Starting from the season 2011 Hobby will replace in the side and front wash room the conventional Thetford C 400 with the new Thetford version C 500. The model for the front wash room will be available only in the right version. For the side wash room however both versions are available (right and left).

Removing the C-500:

Version front bathroom

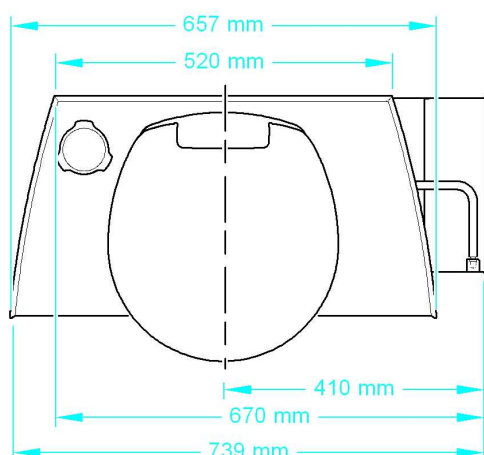
THETFORD
C500

Partno. Thetford: 90518

Version side bathroom right

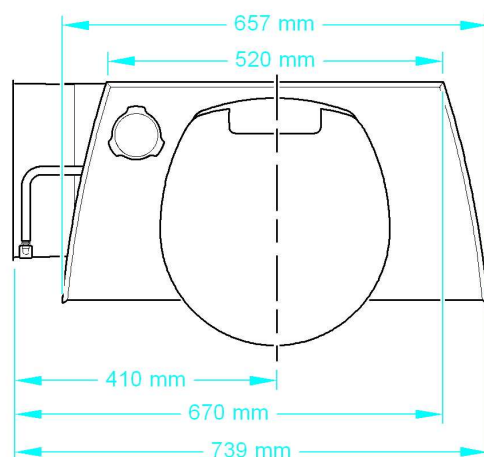
THETFORD
C500

Partno. Thetford: 90519

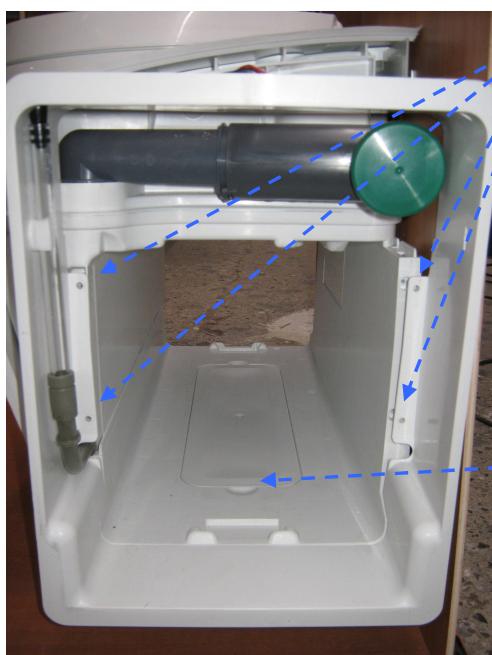
Thetford C500 completely installed (side wash room left). To be able to remove the toilet without problems, please follow the steps prescribed below.

First step is to unscrew the lower connections at the cloakroom wall because you have to pull out the wall later on .

Next step is to unscrew the 4 screws of the tunnel but please don't remove the tunnel! This is necessary to be able to take the cassette out of the washroom later in process.

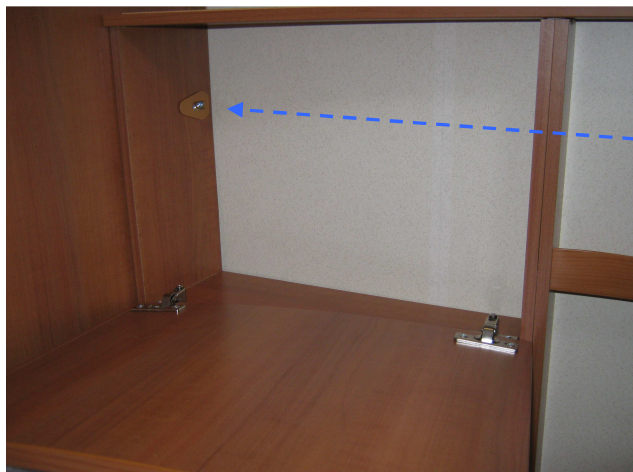
Then take out the cover at the bottom and unscrew the screws below. The 12V cable must be disconnected from the toilet next.

The bottom part of the cupboard in the wash room is divided into segments, that makes the disassembly of the toilet easier. Unscrew the left cabinet element and take it out completely.

After the element of the cupboard has been taken out, the bottom of the cloakroom wall should be pulled out carefully. This is necessary to prevent that the toilet will damage the stop bar of the cloakroom wall. The toilet can now be raised and removed from the washroom.
